# Access Compliance Report

## Public Rights-of-Way

### (Curb Ramps)

Intersection ID: 8303	Main Street: IRMA_ST	Cross Street: CATHERINE_SIMMONS_AV	Location: NW
ADA ID: D18AB4649A7B	Ramp Type: Perp	Initial Pass/Fail: Fail	Overall Compliance: No
Codes/Mitigation Info/Possible Solution		Field Measurements/Component Compliance

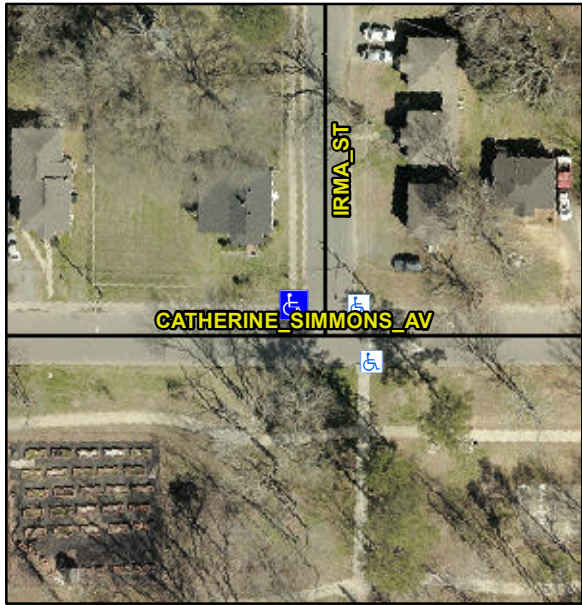
Possible Solutions:		Compliance		Description		Data	Compliance	Description		Data
		Remove & Replace Entire Ramp.		N/A		Ramp Length (in)		59.5	No	Ramp Slope (%)		10.7
				No		Ramp Width (in)		25.0	No	Ramp XSlope (%)		5.0
				N/A		Flare Type LT		N/A	N/A	Flare Type RT		N/A
				N/A		Flare Slope LT (%)		N/A	N/A	Flare Slope RT (%)		N/A
				N/A		Flare Traversable LT?		N/A	N/A	Flare Traversable RT?		N/A
				N/A		Landing Length (in)		N/A	N/A	DWS Provided?		N/A
				N/A		Landing Width (in)		N/A	N/A	DWS Contrast?		N/A
				N/A		Landing Slope (%)		N/A	N/A	DWS Length (in)		N/A
				N/A		Landing X Slope (%)		N/A	N/A	DWS Full Width?		N/A
				N/A		Landing Curb? (Y/N)		N/A	N/A	DWS Offset (in)		N/A
				N/A		Shared Landing?		N/A				
				N/A		Gutter Ponding?		N/A	N/A	Gutter Slope (%)		N/A
				N/A		Gutter Lip Ht (in)		N/A	N/A	Gutter X Slope (%)		N/A
				N/A		Painted X Walk1?		No	N/A	Painted X Walk2?		N/A
						X Walk 1 Direction		To E		X Walk 2 Direction		N/A

Not Found, R304.5.1, R304.2.2, R304.5.3

Remove & Replace Entire Ramp.
